Technical Service Information

ZF4HP22

PREMATURE FORWARD CLUTCH FAILURE

Figure 1

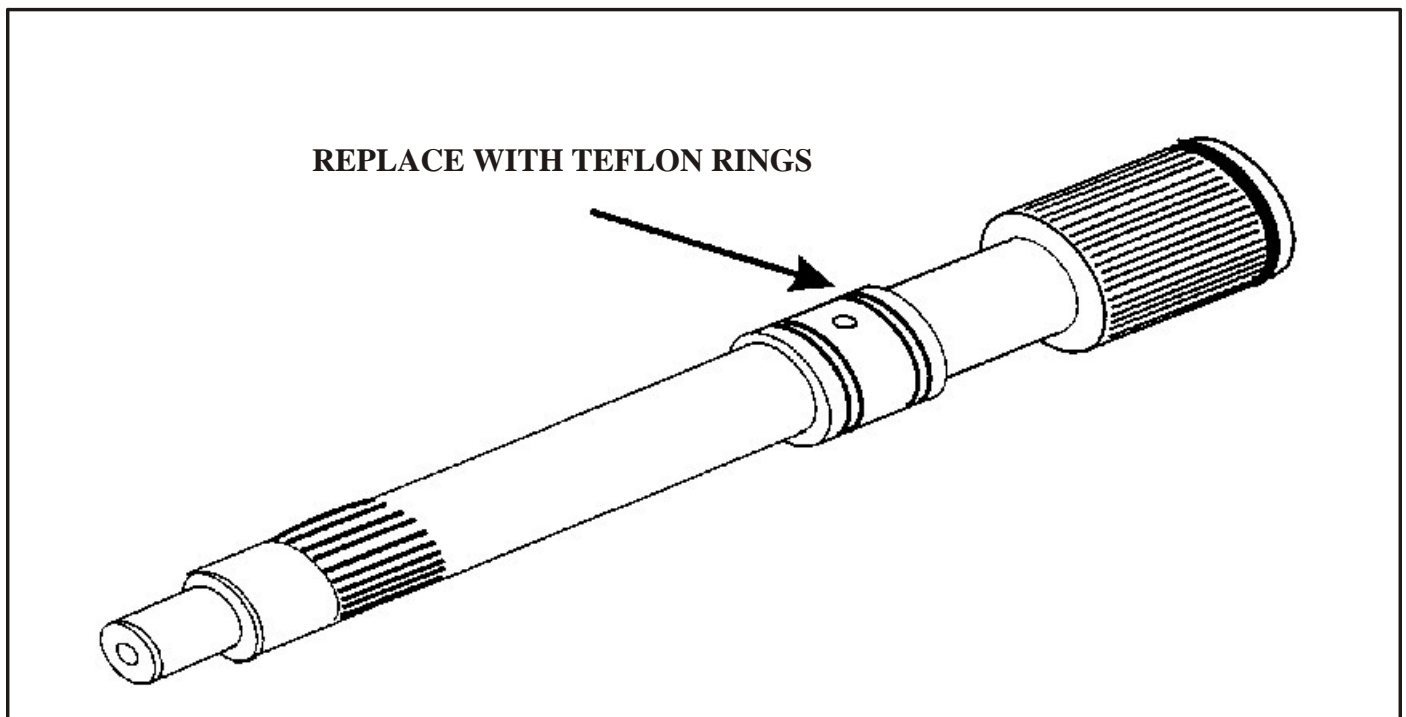
STEP #2. Remove the rear metal turbine shaft ring and *discard it*. Replace the ring with one made of Teflon. Make your own if necessary.(See Figure 1.)

Figure 2

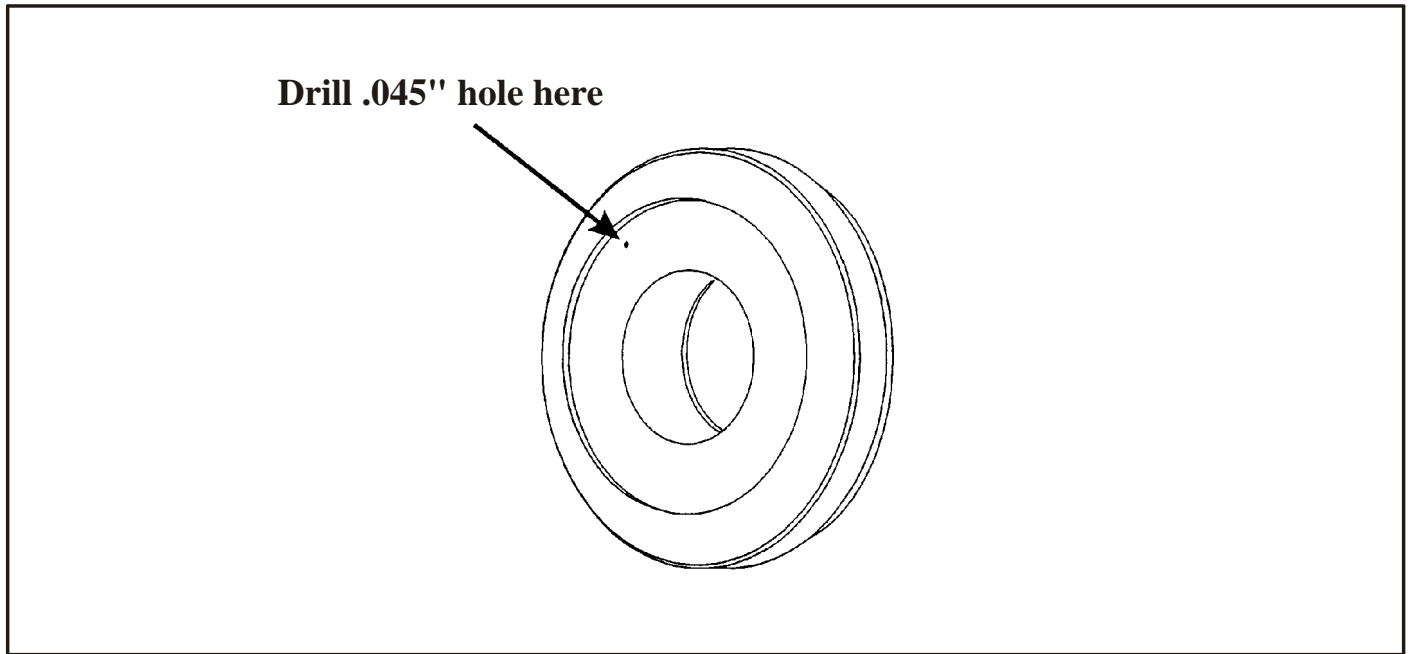
STEP #3 Drill a .045" hole in the Forward Clutch Piston. See figure 2.

Figure 3

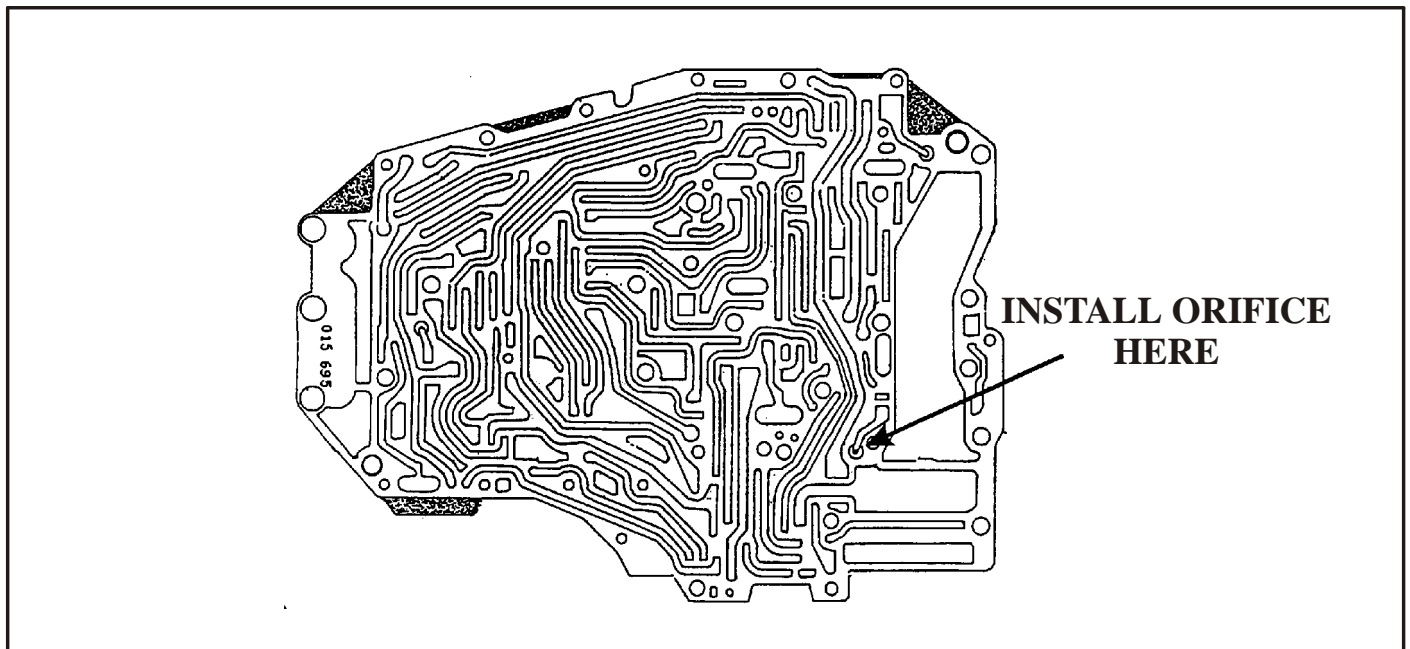
STEP #4 Replace the forward clutch orifice with the larger one found in the ZF correction kit, or drill out the old one to .093" (3/32). See figure #3.

Figure 4

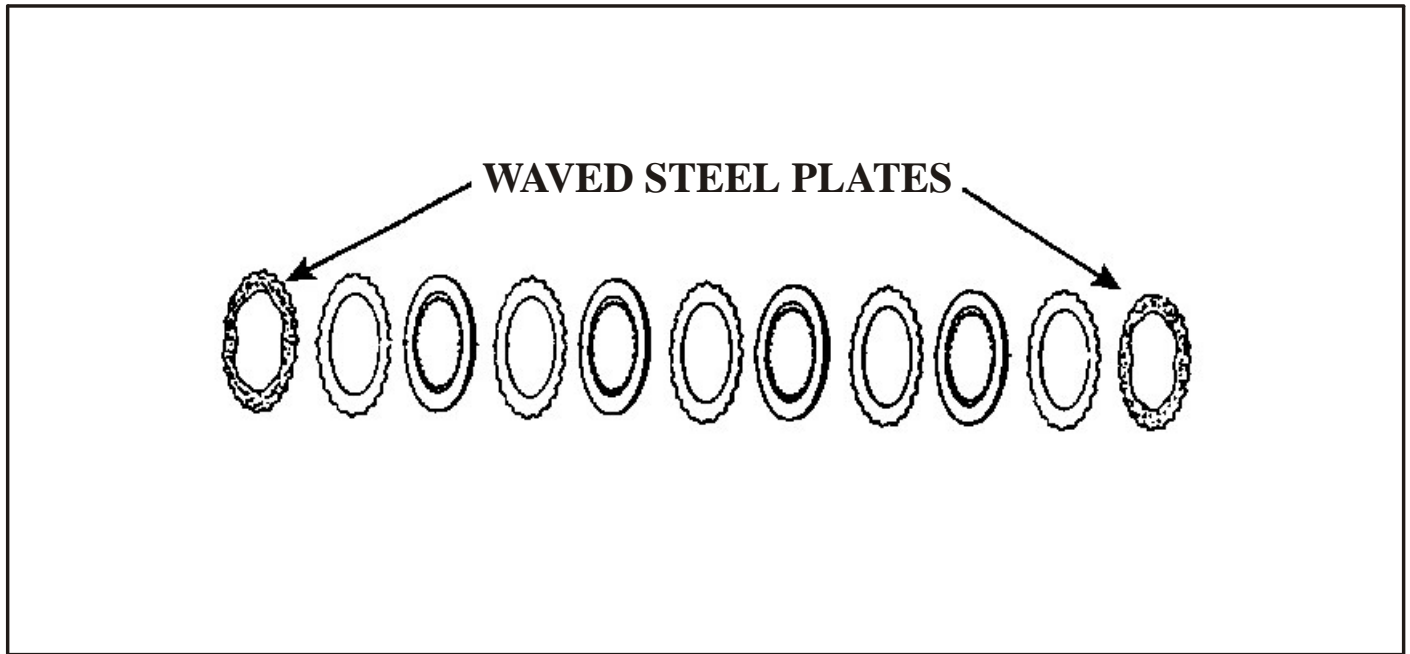
STEP #5 When installing the forward clutches, waved steel plates must be installed at each end of the clutch pack. Clutch clearance should be between .060" and .080". See figure #4.

Figure 5

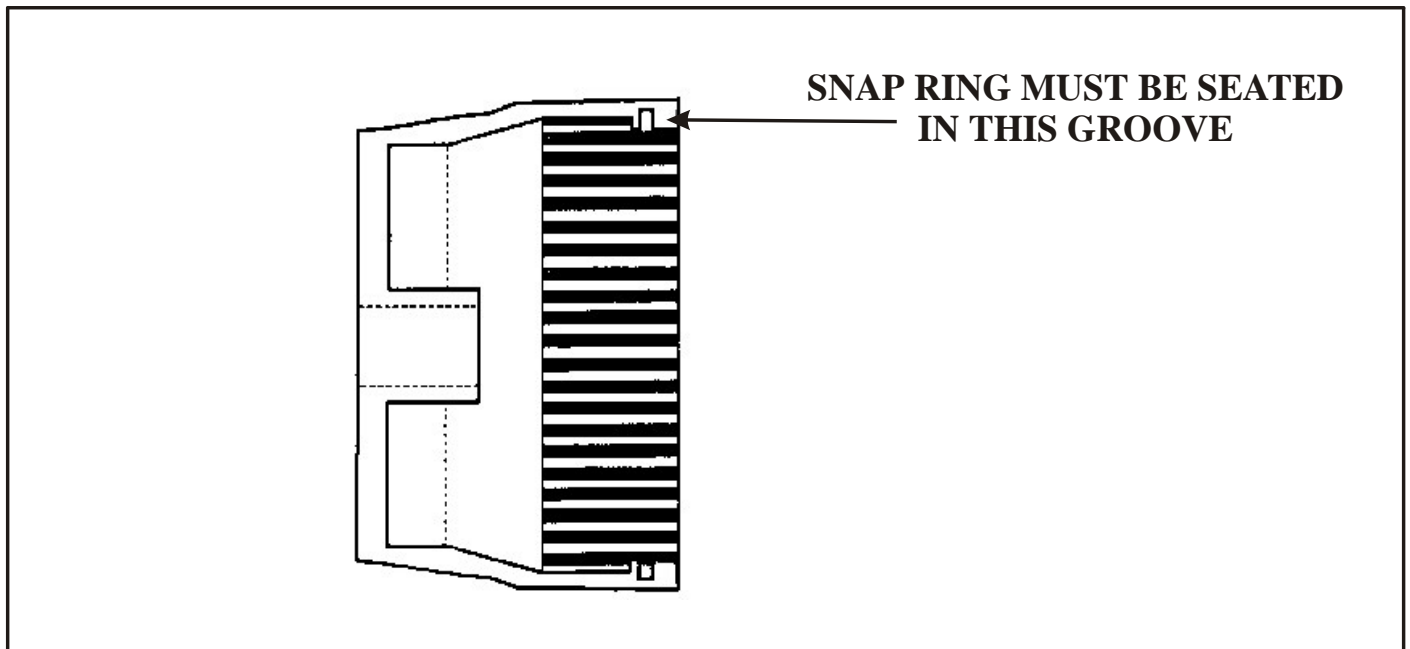
STEP #6 Care must be taken to ensure that the snap ring retaining the forward clutch hub to the drum must be fully seated in the snap ring groove. See figure 5.
